Compute Express Link™ (CXL™)

Engineering Change Notice to the Specification

Type 3 Management Using MCTP CCI

TITLE:	Type 3 Management Using MCTP CCI
DATE:	Introduced date (01/26/2021) Updated date (11/16/2021)
AFFECTED DOCUMENT:	CXL 2.0
SPONSOR:	Vincent Haché, Microchip Mahesh Natu, Intel Chris Petersen, Facebook Joe Cowan, HPe

Figure 123. Example of Fabric Management Model

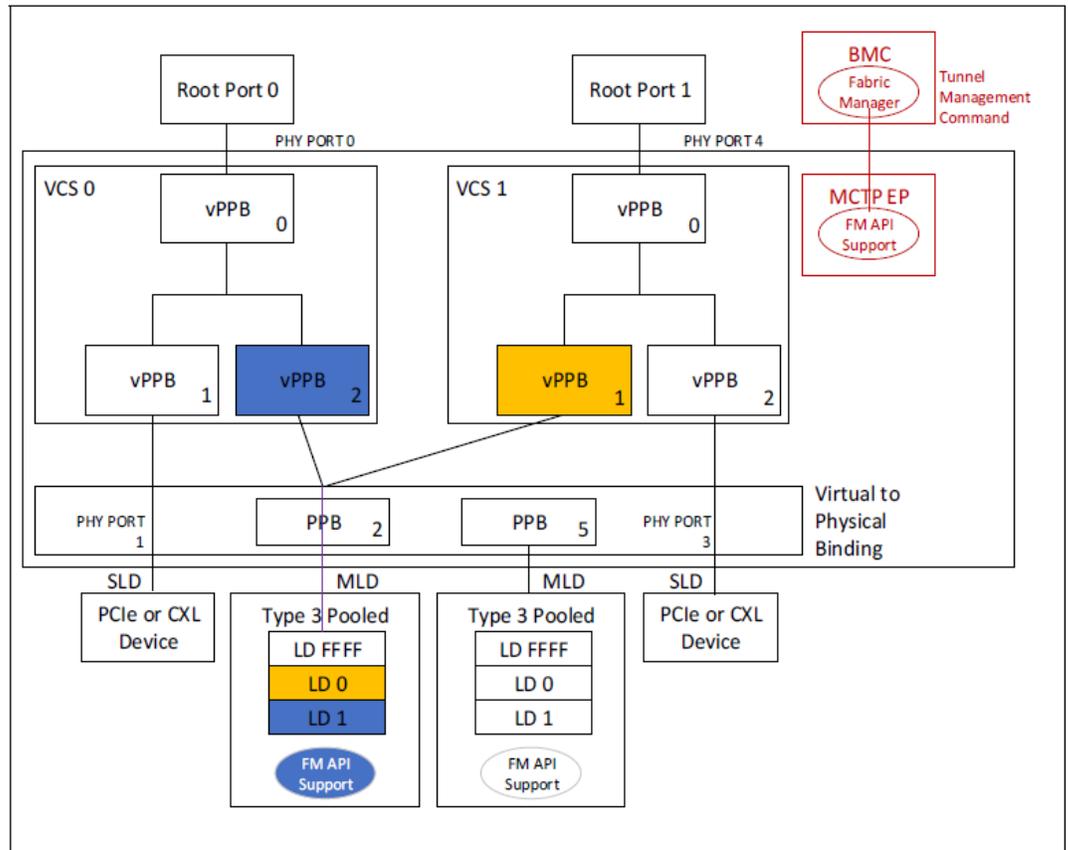
FMs issue request messages and CXL devices issue response messages. CXL components may also issue the "Event Notification" request if notifications are supported by the component and the FM has requested notifications from the component using the **Set ~~00B~~MCTP Event**

Interrupt Policy command. Refer to Section 7.6.3 for transport protocol details. ~~MCTP may be used as the transport protocol.~~

~~MCTP messages may be sent over a variety of interfaces.~~ The following list provides a number of examples of connectivity between an FM and a component's CCI, but should not be considered a complete list:

- An FM directly connected to a CXL device through any ~~⊖~~ **MCTP-capable** interconnect can issue FM commands directly to the device. This includes delivery over ~~sideband~~ **MCTP-capable interfaces buses** such as SMBus as well as VDM delivery over a standard PCIe tree topology where the responder is mapped to a CXL attached device.

- An FM directly connected to a CXL switch may use the switch to tunnel FM commands to MLD components directly attached to the switch. In this case, the FM issues the "Tunnel Management Command" command to the switch specifying the switch port to which the device is connected. Responses are returned to the FM by the switch. In addition to MCTP message delivery, the FM command set provides the FM with the ability to have the switch proxy config cycles and memory accesses to a Downstream Port on the FM's behalf.

Figure 124. FM API CCI Message Body

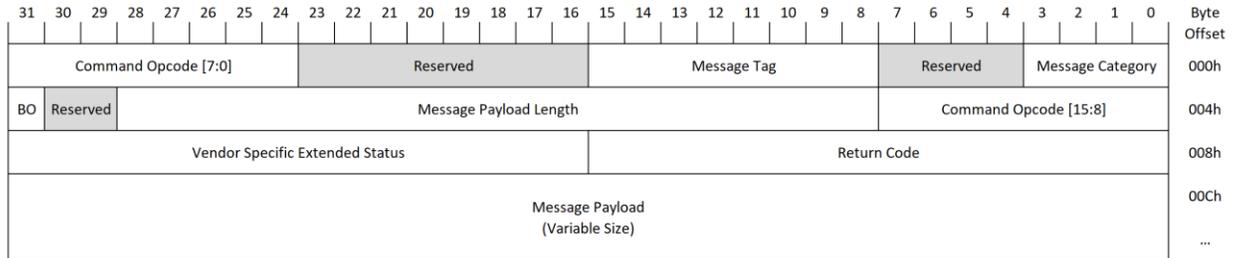
7.6.3 **CCI Message Format and FM Command Transport Protocol**

~~CCI commands are transmitted across MCTP-capable interconnects as MCTP messages using the format defined in Figure 124. FM API commands may be transported as MCTP Message as defined in CXL FM API over MCTP Binding Specification³.~~

Commands from the FM API Command Sets may be transported as MCTP messages as defined in [CXL FM API over MCTP Binding Specification](#)¹. All other CCI commands may be transported as MCTP messages as defined by the respective binding specification.

Figure X. Tunneling Commands to an MLD through a CXL Switch

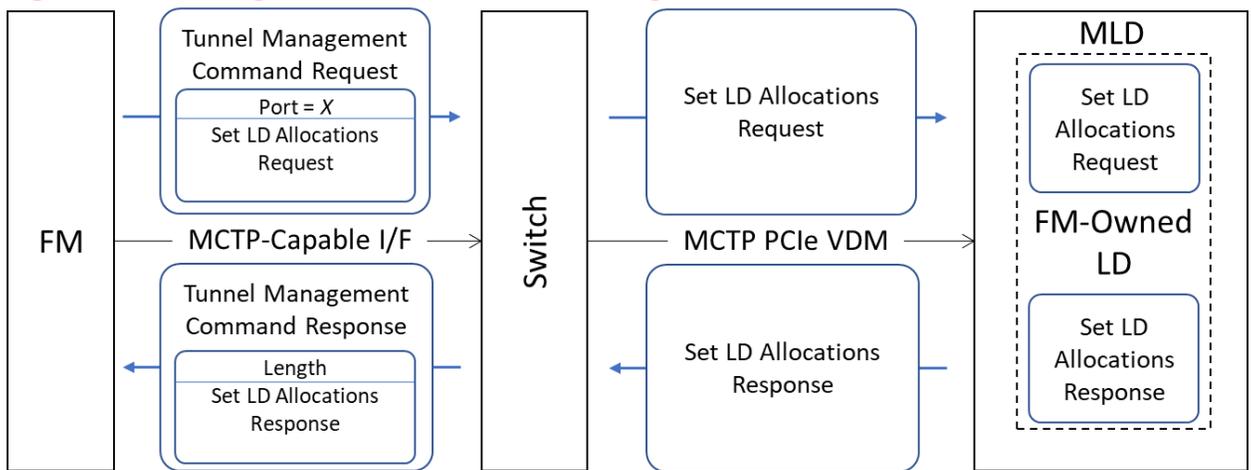
7.6.3.1 Transport Details for MLD Components

MLD components that do not implement an MCTP-capable interconnect other than their CXL interface shall expose a CCI through their CXL interface(s) using the [MCTP PCIe VDM Transport Binding Specification](#). FMs shall use the Tunnel Management Command to pass requests to the FM-owned LD, as illustrated in Figure X.

Figure Y. Tunneling Commands to an LD in an MLD

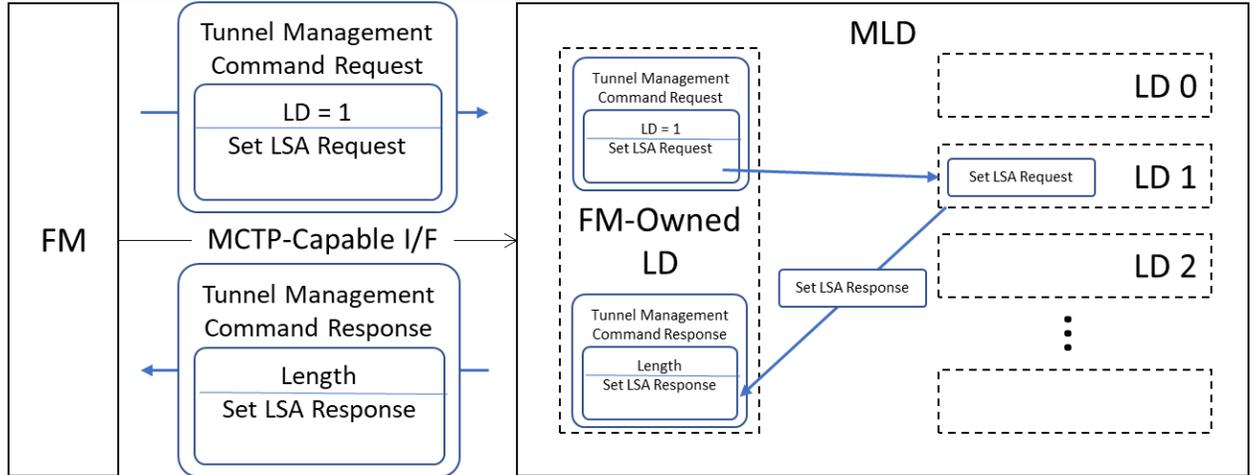
7.6.7.4.1 Tunnel Management Command (Opcode 5300h)

This command is used to tunnel FM-C commands *encapsulated as an MCTP request* to LDs within an MLD.

When sent to a CXL switch, the provided command is tunneled by the switch to the FM-owned LD (LD=0xFFFF) of the MLD on the specified port using the transport defined in Section 7.6.3.1.

When sent to an MLD, this provided command is tunneled by the FM-owned LD to the specified LD, as illustrated in Figure Y.

Figure Z. Tunneling Commands to an LD in an MLD through a CXL Switch

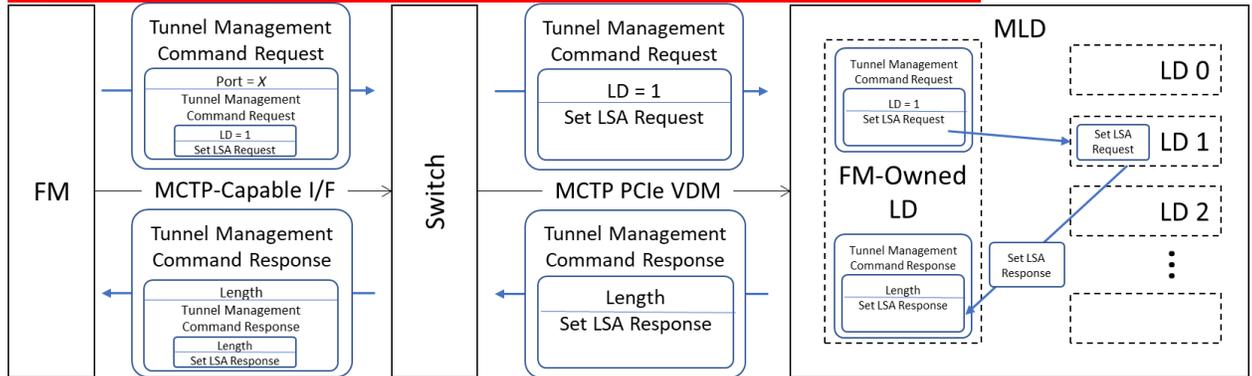
The Management Command input payload field includes the tunneled command encapsulated in the CCI Message Format, as defined in Figure 124. This can include an additional layer of tunneling for commands issued to LDs in an MLD accessible only through a CXL switch’s MLD port, as illustrated in Figure Z.

Response size varies based on the tunneled FM command’s definition. Valid targets for the tunneled commands include switch MLD ports and valid LDs within an MLD. Tunneled FM commands sent to any ~~port other targets than an MLD port~~ shall be discarded and this command’s will indicate complete with an “Invalid Parameter” return code-failure. The FM-owned LD (LD=0xFFFF) is an invalid target.
